Highways Service

Project Code:	210339H
Project Name:	Belle Vue Greyhound Stadium
Date:	Wednesday, 16 July 2025
Technical Review:	11th & Final.

Section 38 Plans and Drawings.

Drawing No. ELL-18039-B-CS-550 - Section 278 General Arrangement Plan, Revision V.

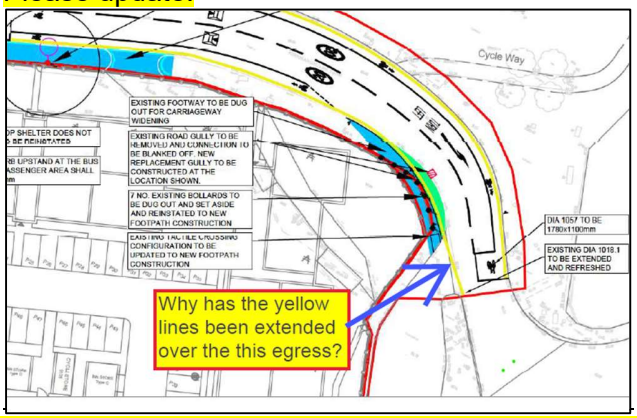
2. ~~Please review and update the traffic calming locations along Kirkmanshulme Lane as per the markup PDF *'Proposed Speed Cushion Location and Design Review'* supplied with this review.~~
   - ~~As per the PDF markup provided at the last review, please confirm if a design check has been done to confirm if 3 cushions be installed where highlighted.~~
     ~~See image below and update design.~~
     ~~Updated~~
     ~~Comment Closed.~~

- ~~The Keep Left Bollard on the proposed traffic islands are not shown as requested.~~
  ~~Comment Closed.~~

- ~~Speed Cushion on the northside of the traffic island near Pink Boar Lane is shown in the wrong location.~~
  ~~Comment Closed.~~

- As per the PDF markup provided at the last review, design contours shown at Redgate Lane Junction are to be removed from this drawing.
  ~~Comment Closed.~~

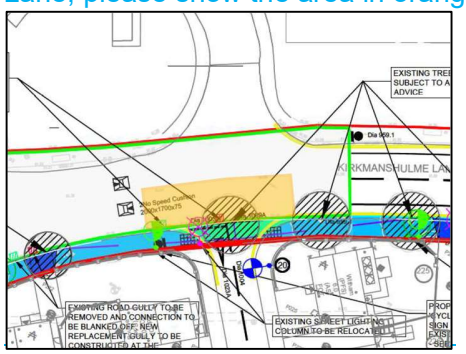
- Remove the green box (related to the now complete Coop Academy works) and show the road makings and other installed furniture as existing road markings to provide context for the proposed speed cushions in that area.
     This has not been done, please update as requested.
     Comment Closed.

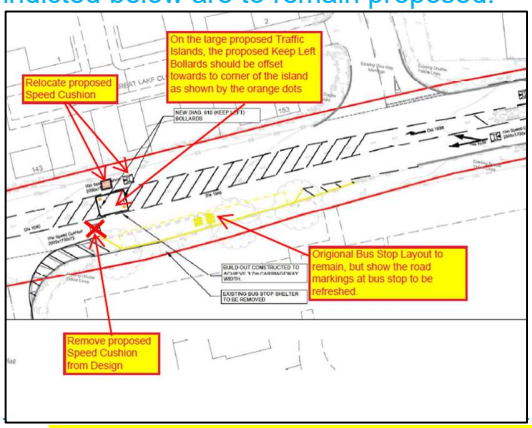
11. The bus stop cage near the junction of Scenic Street should be 20m long x 3m wide as this would match what was previously in place. Please update the design to reflect this.
Please confirm what is proposed?
Comment Closed

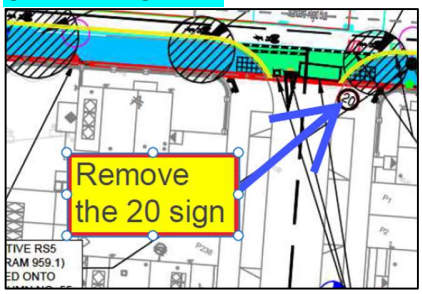
12. After review of the proposed S278 traffic calming design, it has been concluded that the existing layout of the bus stop including its shelter, near Pink Boar Lane should be retained. Please update the design to reflect this and note that road markings including the bus stop cage should be refreshed. The proposed Traffic Island and traffic calming as indicted below are to remain proposed.

- The road hatching on the west side of the bus stop is wider the bus stop cage, please review.
- Speed Cushion at the traffic island is shown in the wrong location.

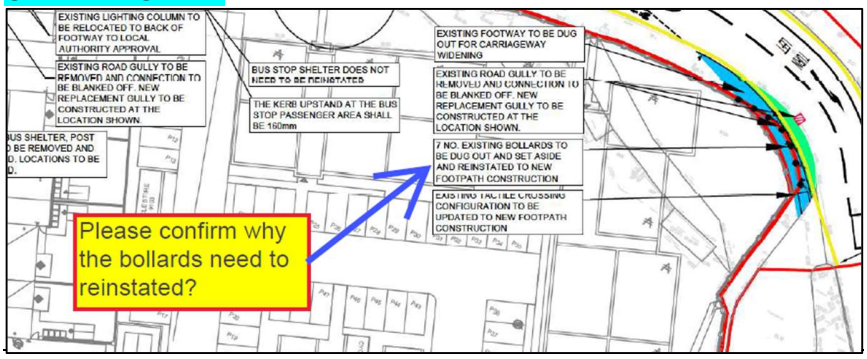
18. Remove the 20mph sign shown in the image below.
Comment Closed

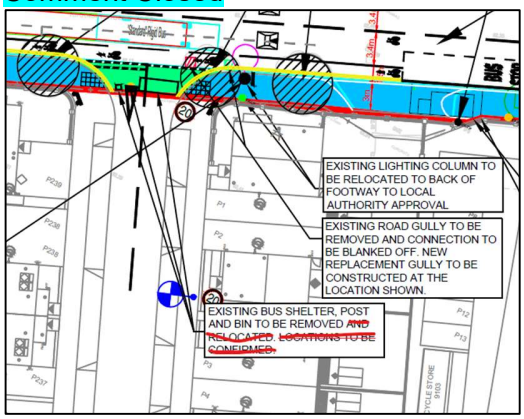
19. The bollards noted in the below image are proposed to be reinstated and it appears the reinstated bollards will block the footway. Are the bollards required? Please review.
Comment Closed

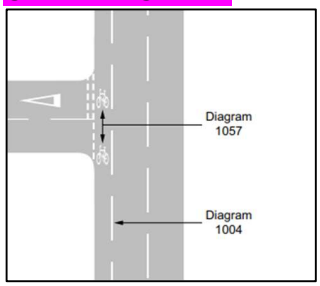
20. Remove text from annotation shown in image below
Comment Closed

Drawing No. ELL-18039-B-CS-553 - Section 278 Road Marking and Signage Layout Revision Q

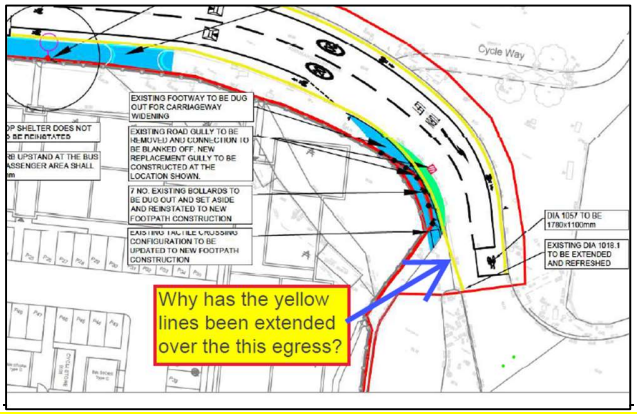
- ~~As per the PDF markup provided at the last review, please confirm if a design check has been done to confirm if 3 cushions be installed where highlighted.~~
  ~~See image below and update design.~~
  ~~Removed~~
  ~~Comment Closed.~~

- ~~The Keep Left Bollard on the proposed traffic islands are not shown as requested.~~
  ~~Comment Closed.~~

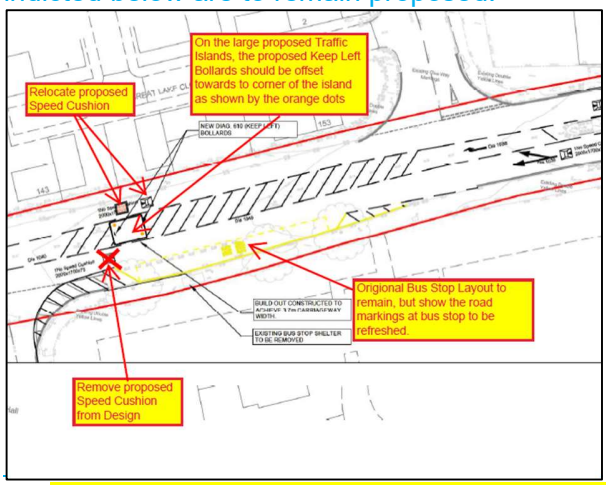
6. ~~The layout of the traffic island, traffic calming and its interaction with bus stop at the Pink Boar Lane junction is not acceptable. The current proposed layout will mean vehicles will swerve round the traffic calming into the bus stop as a bypass. Please provide an alternate solution. Please also refer to RSA 2 problem 7 and our OO response as this also highlights issues with design.~~
~~Comment Closed~~.

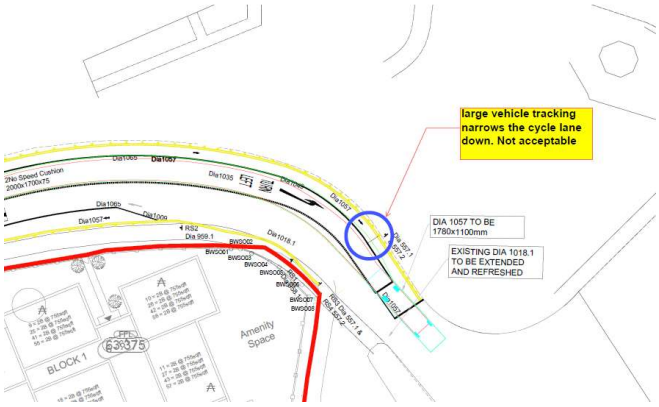
15. Please ensure cycle marking 1057 proposed is shown correctly where the cycle lane crosses in front of side roads or accesses (new or existing), Refer to image below and Traffic signs Manual Chapter 3, paragraph 11.3.6 and figure 11-2 for guidance.
Cycle marking diag 1057 not shown correctly at junctions. Update as requested above.
Updated.
Comment Closed.
